County of Fairfax, Virginia

Re: Interpretation for SE 2003-LE-036, Rose Hill Park, Tax Map Parcel 82-3 ((18)) 46, 47, 48, 53, and 54; 92-1 ((7)) 1-8, 27-45, 55-63; 92-1 ((8)) 1-18: Elevations

Re: Request for Interpretation-Rose Hill Park
SE 2003-LE-036
Applicant: Stanley Martin Homes

INTERPRETATION PLAN

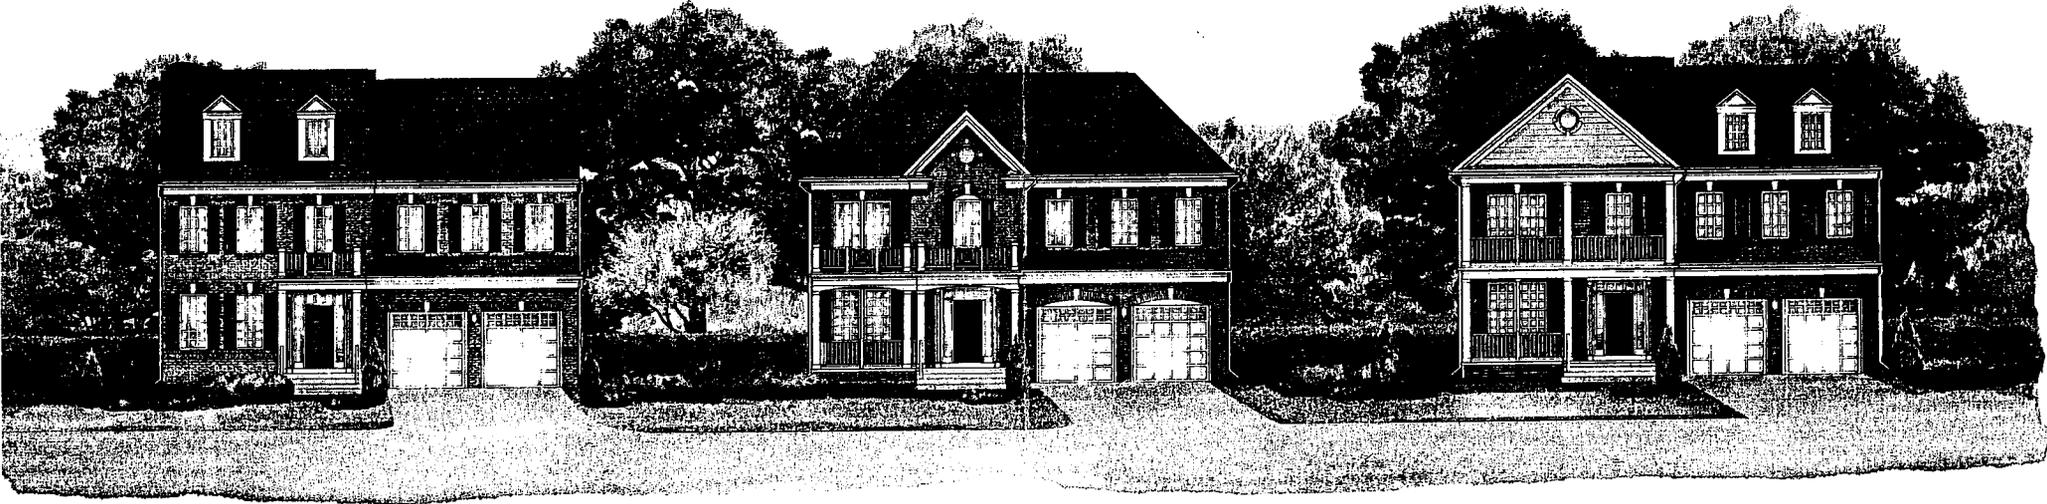
The three proposed uphill elevations show two units with gable roofs and gabled dormers and one unit with a hip roof and gable, separate garage doors with a row of windows and arched detailing on one of the models, widened bay windows on two of the units, and wider stairways leading to the entrance door than originally proposed. The garages are located under the first floor of the uphill units. The three proposed downhill elevations show two units with gable roofs and gabled dormers and one with a hip roof and gable, keystone lintels above windows, separate garage doors with windows, one set of garage doors with arched detailing above, mullioned windows, front porches and balconies on two units and a balcony on the third unit, and articulated facades.

- Both the downhill units and the uphill units include an elevation with a hip roof in addition to the gable roof. The modified hip roof is similar to the elevations on the SE Plat, but conforms to Zoning Ordinance requirements.
- Several of the front façades include second story porches and a roof extension over the garage doors.

- The bay windows on the uphill units have been widened to enhance the appearance of windows on each façade.
- The staircases on the uphill units have been widened to create a more significant entry to each home.
- All uphill units have two (2) garage doors in lieu of a wider single garage door.
- Arched elements have been included over the garage doors where appropriate to complement the architectural design.

Based on the above, it is my determination that the proposed elevations are in substantial conformance with the development conditions and the SE plat provided that a minimum of one third of the dwellings are built with hip roofs. This determination has been made in my capacity as the duly authorized agent of the Zoning Administrator. If you have any questions regarding this interpretation, please feel free to contact Mary Ann Godfrey at (703) 324-1290.

SEE RESPONSE LETTER DATED 8-30-10
